ATTACHMENT NO. 1 TO AEP:NRC:0894E

TECHNICAL SPECIFICATION CHANGE DESCRIPTIONS

Change No. 1

Unit No. 1; Page 3/4 4-27; Figure 3.4-2
 Page 3/4 4-28; Figure 3.4-3
 Page B 3/4 4-6; Section 3/4 4.9
 Page B 3/4 4-10; Table B 3/4.4-1
 Page B 3/4 4-11; Section 3/4 4.9

Figure 3.4-2

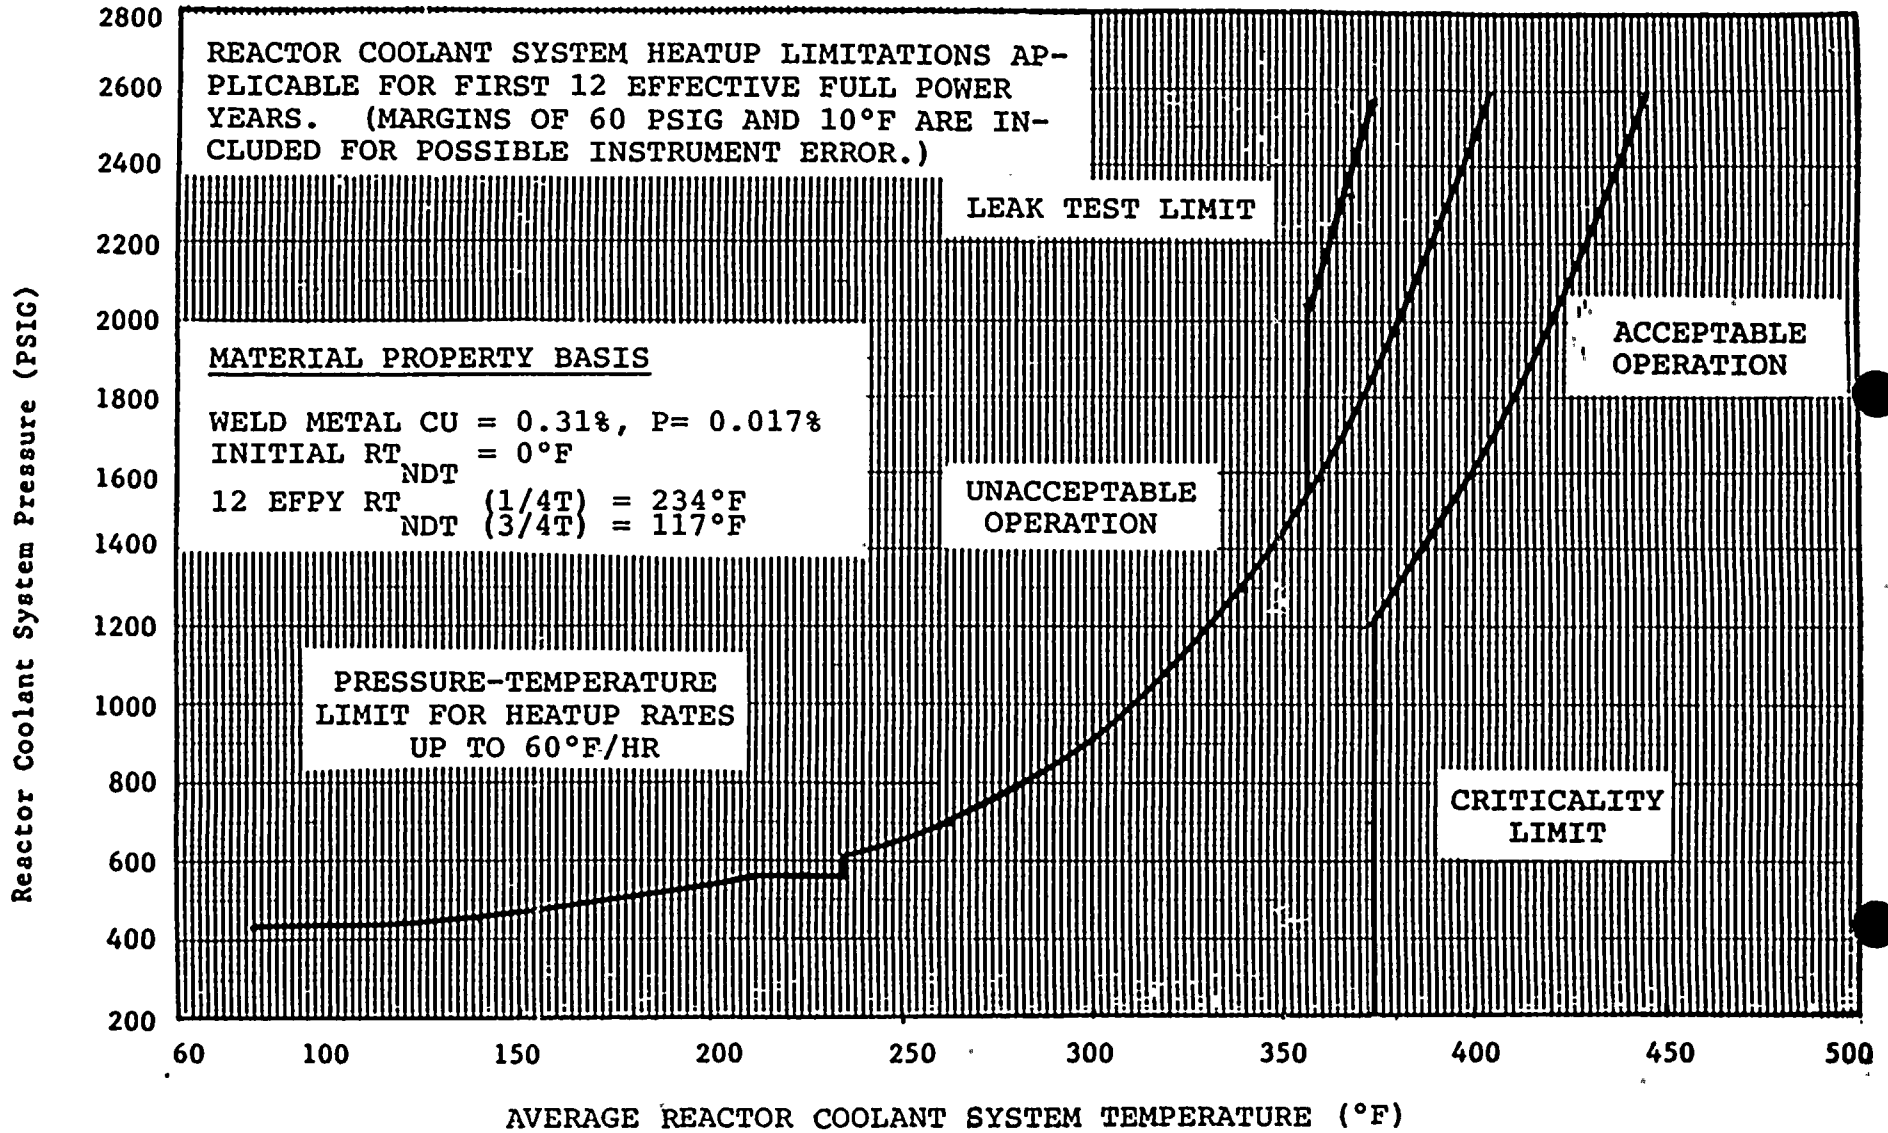
Figure 3.4-2 and Figure 3.4-3 are the heatup and cooldown curves for Unit No. 1. These curves are composite curves prepared based upon the most limiting value of the predicted adjusted reference temperature at the end of 12 EFY. The revisions to the curves reflect the analyses done as a result of the capsule (Y) testing by Southwest Research Institute and the material data for the reactor vessel beltline region weld chemistry noted in our letter AEP:NRC:0894C dated July 3, 1985. The assumptions and limitations used in the development of the curves are noted in the revised bases. These revised curves supersede the curves submitted for Unit No. 1 in our earlier submittal No. AEP:NRC:0894 dated February 14, 1985.
